Affected Models:
Emira V6
2024/2025 Selected
Model Year VIN Range

Number:
131-25020

Updating the ECM (Engine Control Module), to the latest level software.

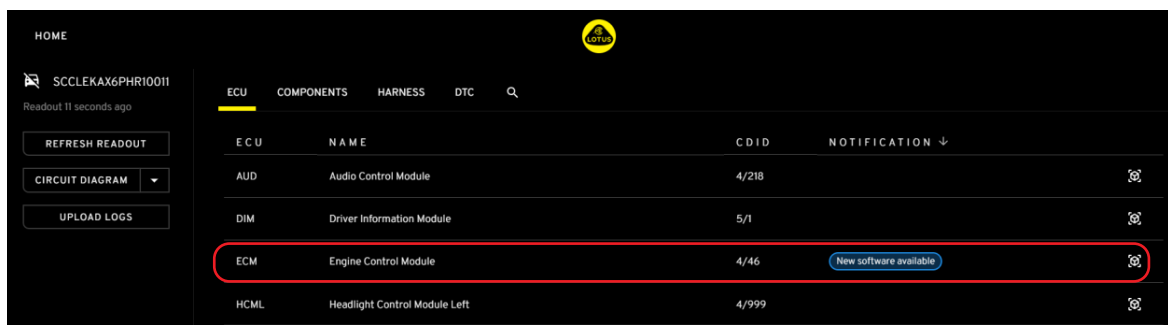
Locate the ECM as shown in the image

Select the ECM update under the software menu, following the instructions provided on the screen to complete the update.
